**Appln No. 10/581,782**  
**Amdt date August 6, 2008**  
**Reply to Office action of April 21, 2008**

**REMARKS/ARGUMENTS**

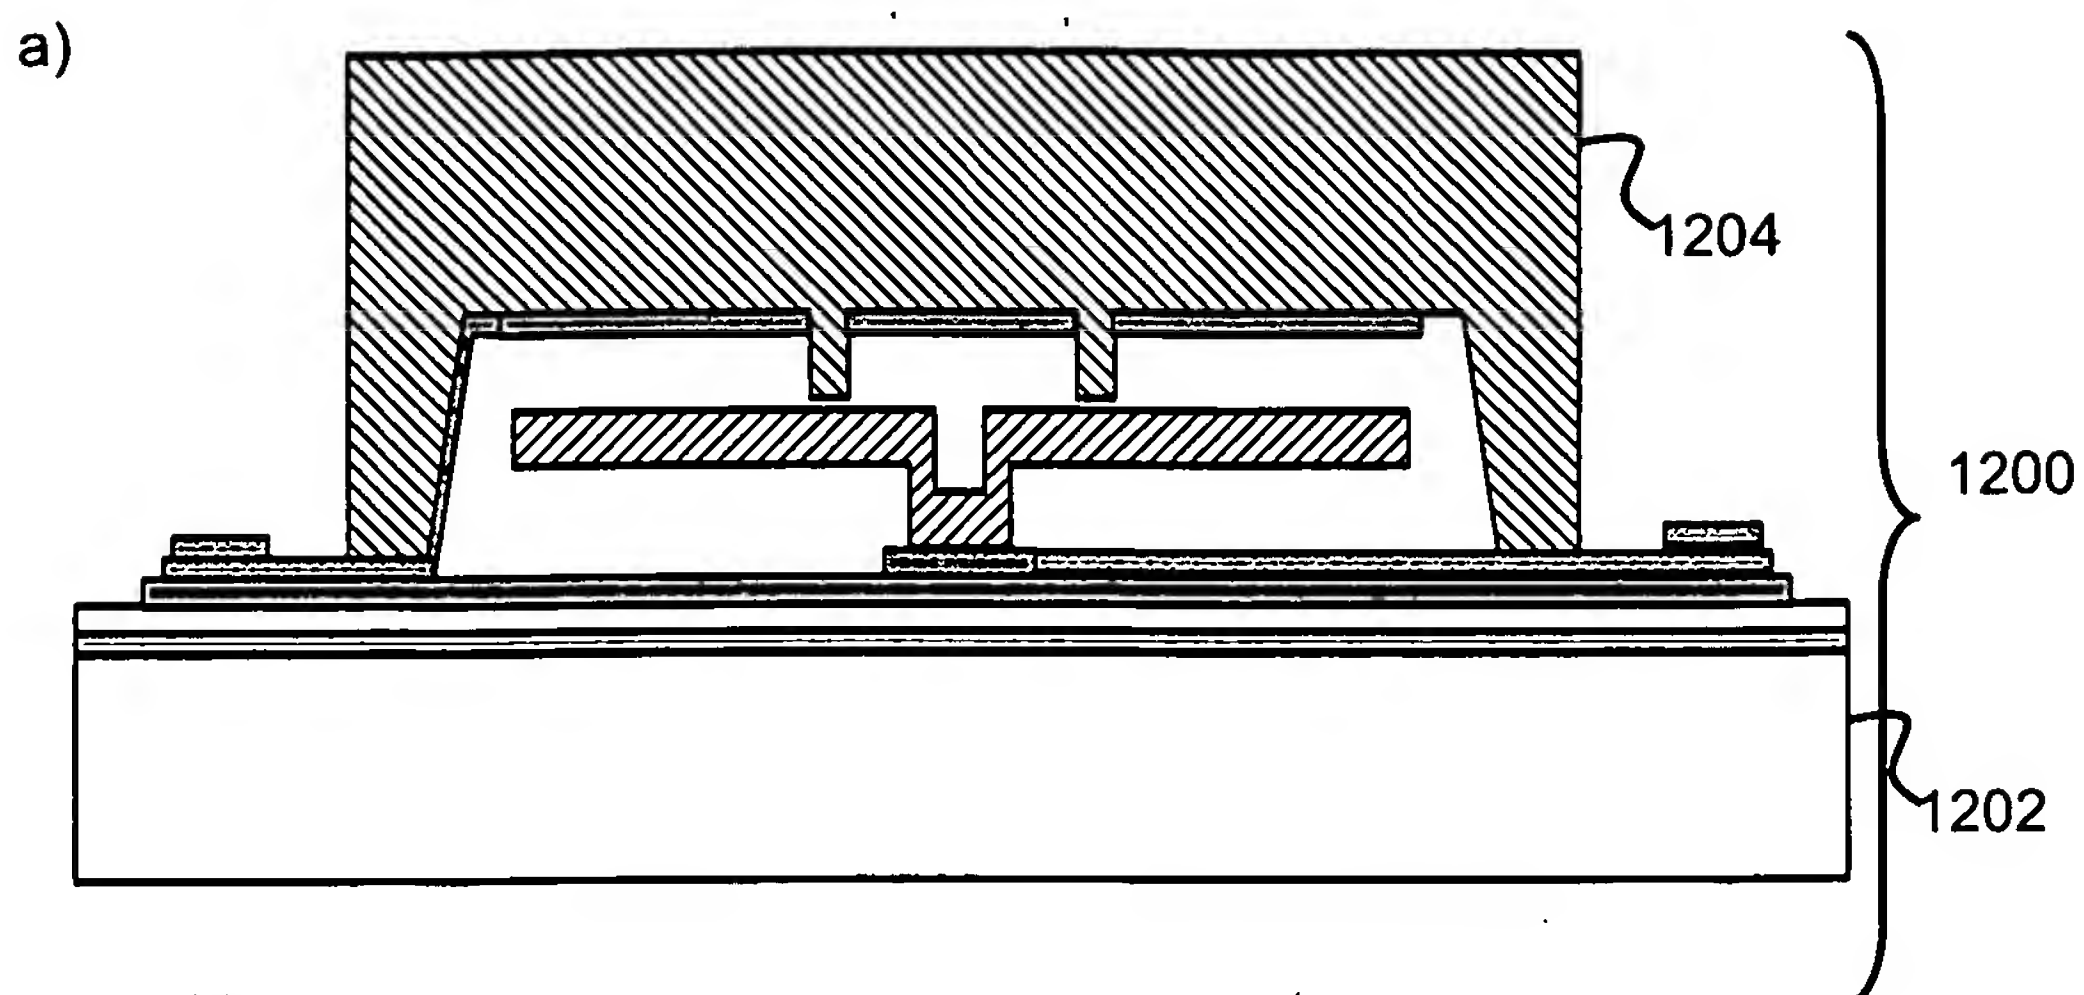
The drawings are objected to because "the key for FIG. 12 indicates solid black as being both the nitride and the metal materials," and that the "support structure" of claim 1 & "contact member" of claim 2" must be shown. A replacement drawing for FIG. 12 correcting the key is enclosed.

The drawings are also objected to on the grounds that the reference characters 102 and 1210, have both been used to designate the diaphragm.

Claims 3, 4 and 13 are objected to under U.S.C. 112, first paragraph, on the grounds that the specification fails to enable the claimed invention

The attached annotated sheet of drawings is a includes changes to FIG. 12. The attached replacement drawing of FIG. 12 replaces the original informal sheet including FIG. 12.

Applicant respectfully submits that it is permissible to use different reference characters to designate different exemplary embodiments of the diaphragm. It is clear from the description, that the structures shown in FIG. 1 and FIG. 12 are different embodiments, and therefore it is appropriate to use different reference characters for the two different embodiments.

Therefore, in FIG. 12(b), the diaphragm 1210 is at the "bottom" of the drawing, and has been created by the backside wet etch as described. On the other hand, the structure 1204 at the "top" is the device base in this embodiment. As a result, the specification enables the invention, as claimed by claims 3, 4 and 13.
